**Planning & Development Division**  
*Planning & Economic Development Department*

<b>File Number</b>	PL 24-036	<b>Contact</b>	Jason Mozol, <a href="mailto:jmozol@duluthmn.gov">jmozol@duluthmn.gov</a>	
<b>Type</b>	MU-I Planning Review	<b>Planning Commission Date</b>	July 9, 2024	
<b>Deadline for Action</b>	<b>Application Date</b>	June 7, 2024	<b>60 Days</b>	July 6, 2024
	<b>Date Extension Letter Mailed</b>	May 21, 2024	<b>120 Days</b>	September 4, 2024
<b>Location of Subject</b>	1420 London Rd			
<b>Applicant</b>	Kyle Hammer	<b>Contact</b>		
<b>Agent</b>	Kelly, Mortenson, DSGW	<b>Contact</b>		
<b>Legal Description</b>	010-1440-2100 and 010-1440-12110			
<b>Site Visit Date</b>	June 24, 2024	<b>Sign Notice Date</b>	June 20, 2024	
<b>Neighbor Letter Date</b>	May 24, 2024	<b>Number of Letters Sent</b>	32

**Proposal**

The applicant is proposing to demolish the existing dental clinic and construct a new 7,000 sq. ft clinic building. There is not a MU-I district plan for the site, so individual Planning Review is required.

JPI ENGINEERING, INC  
 5670 Miller Trunk Hwy  
 Duluth, MN 55811  
 Phone: (218) 720-6219  
 www.jpjeng.com  
 Hibbing, MN • Duluth, MN

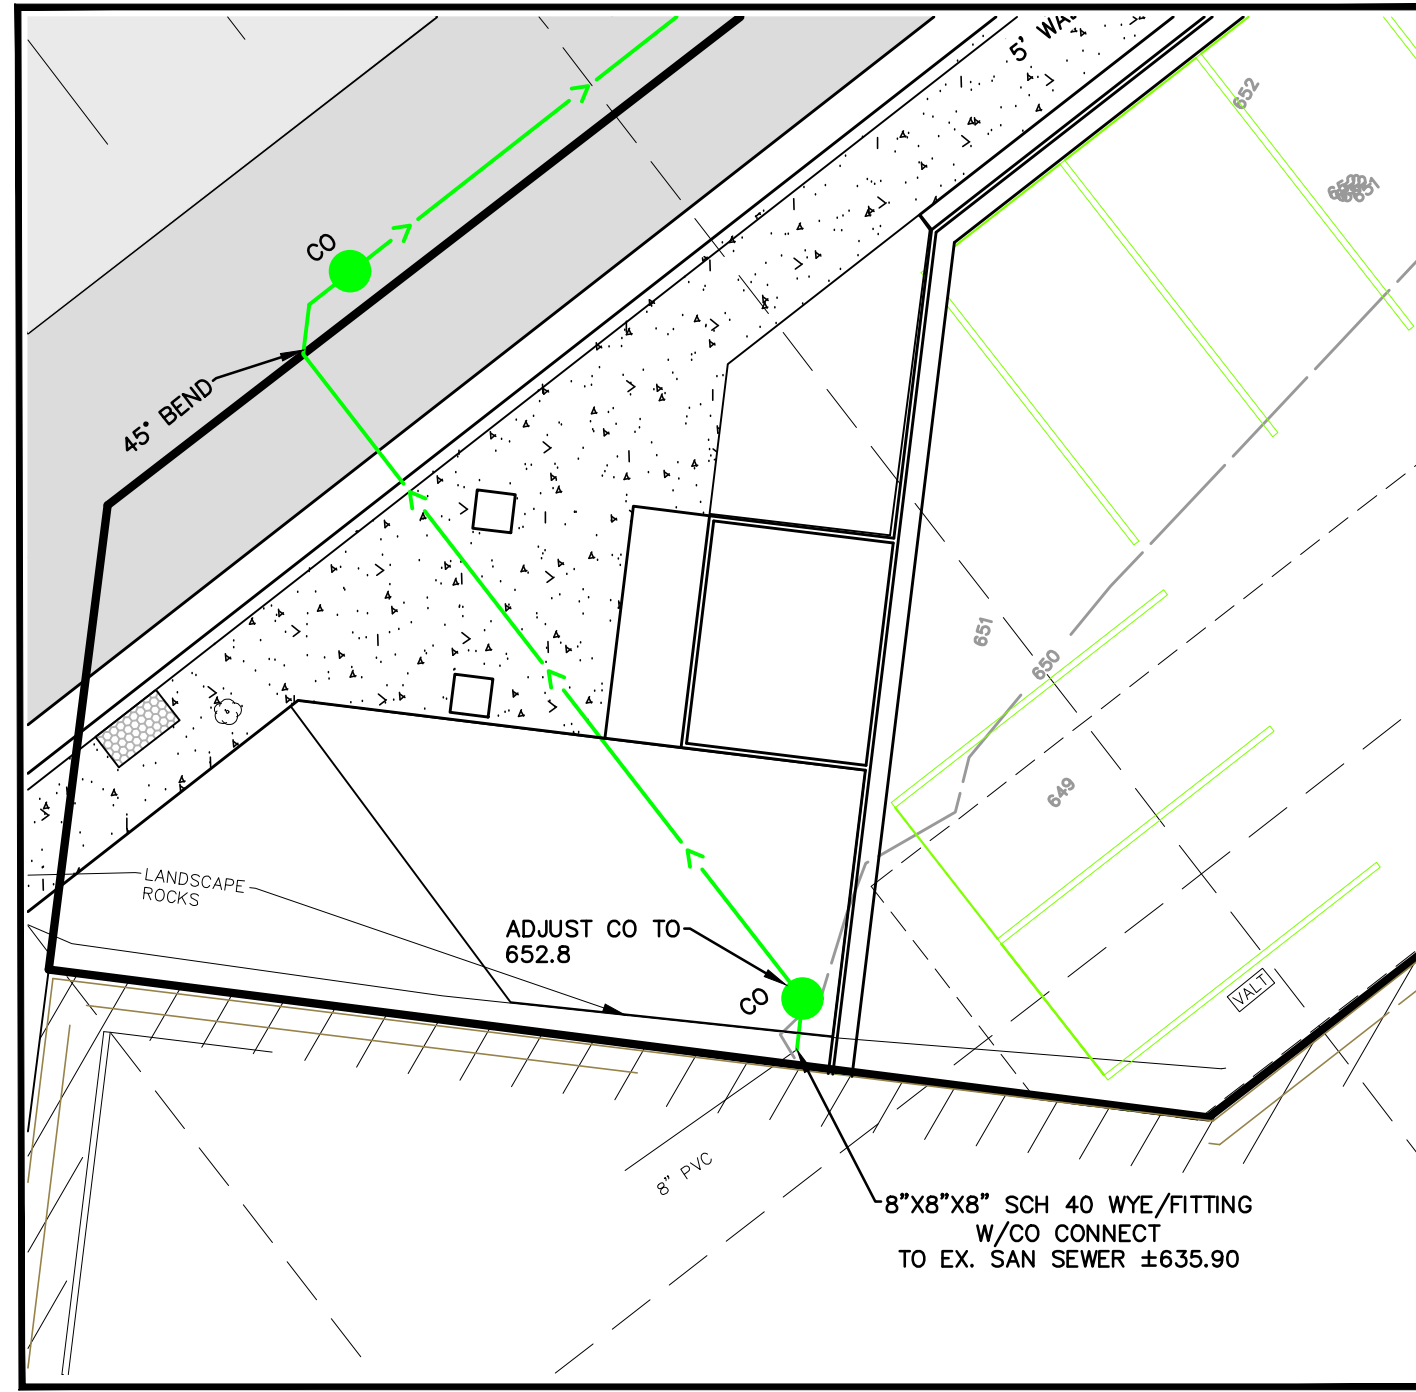
- 2) UDC 50-24 Sec. (Parking and loading). A maximum of 42 parking spaces are allowed on this site. 24 parking spaces will be provided, 14 in an underground ramp and 10 in a surface lot. Parking aisles and spaces meet the dimensional standards. 3 bike parking spaces are required. The applicant must submit a site plan and exhibit depicting the location of bike parking and rack design, and this must be approved by the Land Use Supervisor prior to receiving a building permit.

- 3) UDC Sec. 50-25 (Landscaping and tree preservation). This project must provide frontage landscaping along London Rd and S 15<sup>th</sup> Ave E, tree canopy coverage of parking areas, interior parking lot landscaping and replace trees removed from the site. A landscape plan was submitted that lacked calculations for canopy coverage and interior parking lot plantings, and placed frontage landscaping in the right-of-way. The applicant must submit landscaping plan that meet Sec. 50-25 standards, and this must be approved by the Land Use Supervisor prior to receiving a building permit.

- 1) The applicant shall submit a site plan and exhibit depicting conformity with bike parking requirements of the UDC;
- 2) Applicant shall submit a landscaping plan that fully conforms with the requirements of the UDC;
- 2) Applicant shall submit a lighting plan with photometric plan and drawings for fixtures that fully conforms to the requirements of the UDC;
- 3) Applicant shall construct and maintain the project as identified in the attached exhibits.
- 4) Any alterations to the approved plans that do not alter major elements of the plans may be approved by the Land Use Supervisor without further Planning Commission; however, no such administrative approval shall constitute a variance from the provisions of UDC Chapter 50.
